Drawing Amendments

Remarks

In view of the Examiner's restriction requirement, the title has been amended to PANEL ASSEMBLY APPARATUS, which is believed to better describe the currently claimed subject matter.

PERCAD-Bayonne, N. J.
EXHIBIT
A

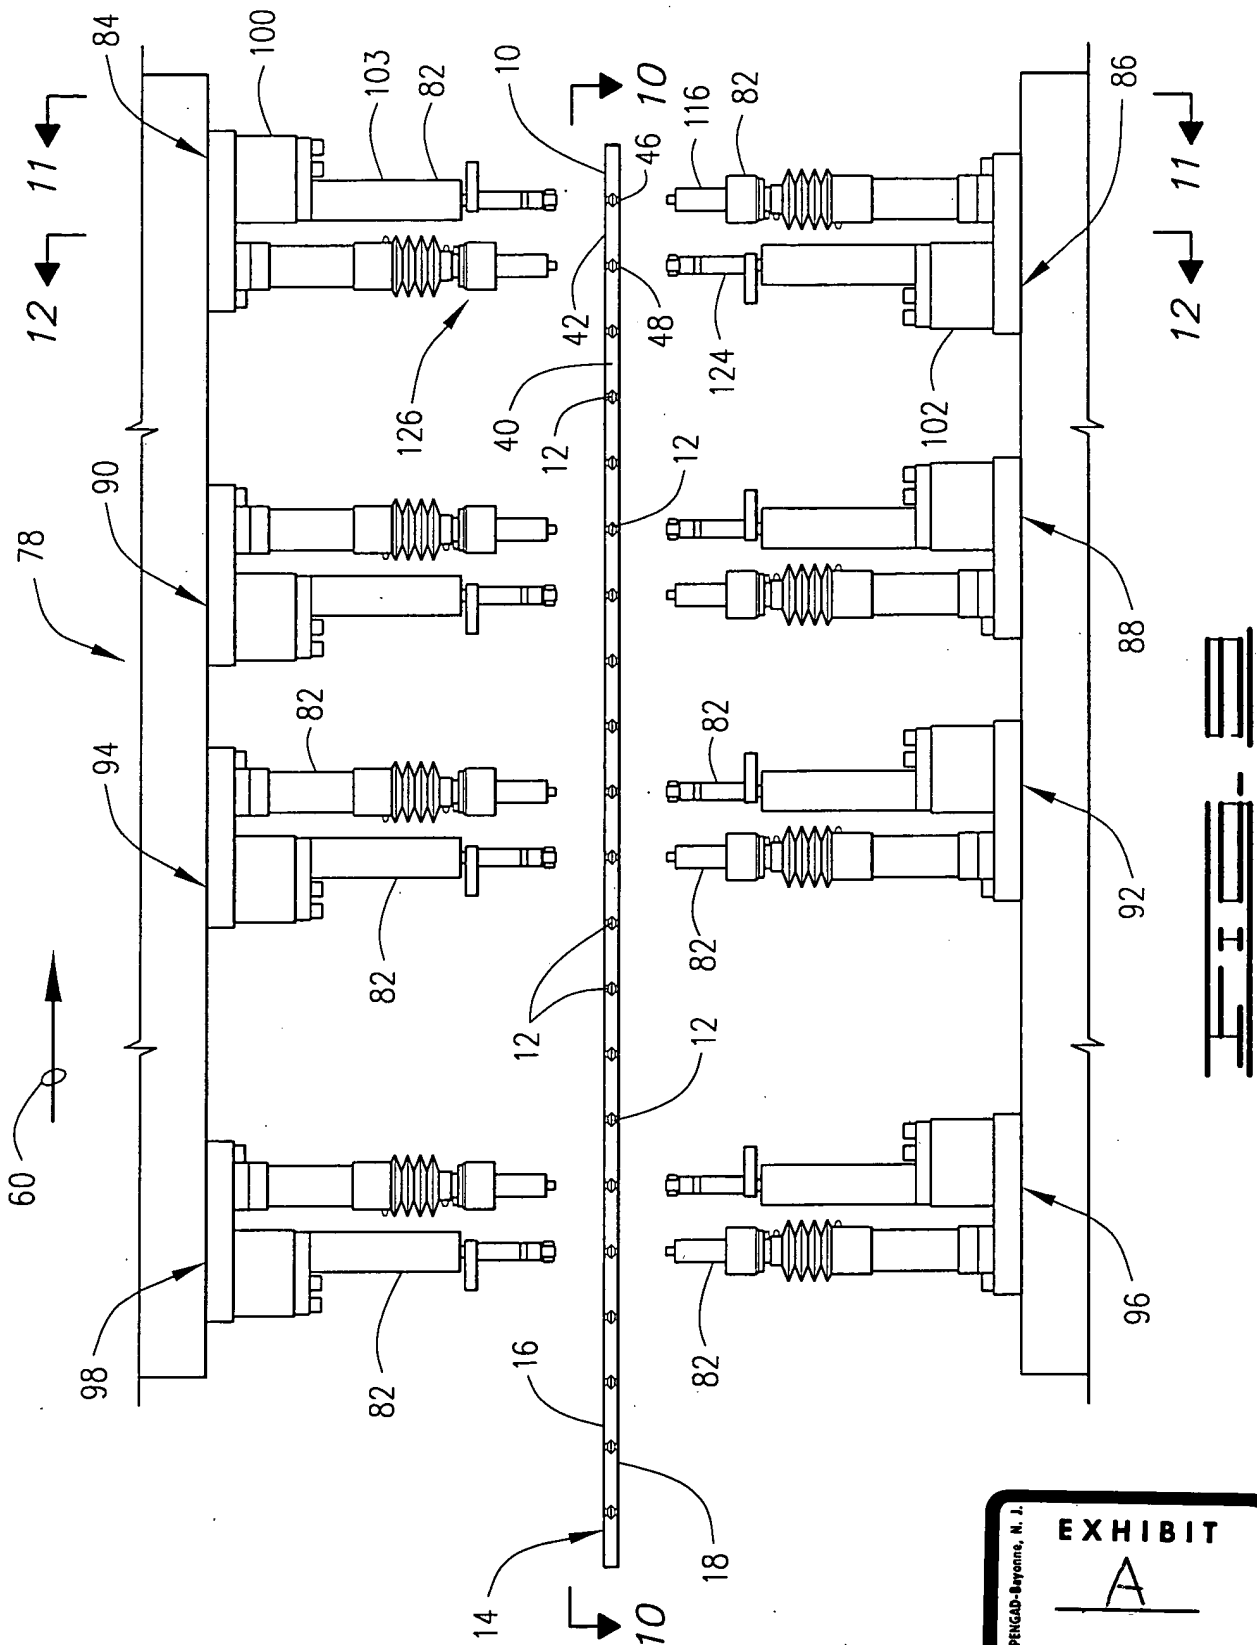
In the course of preparing this response, it was noted that the lead line arrow of reference numeral 86 in Figure 9 fails to point to the second row of welding stations. This error has been corrected by a replacement drawing sheet 7.

Amend Figure 9 by accepting replacement sheet 7, attached as Exhibit A. An additional copy of this sheet is submitted herewith
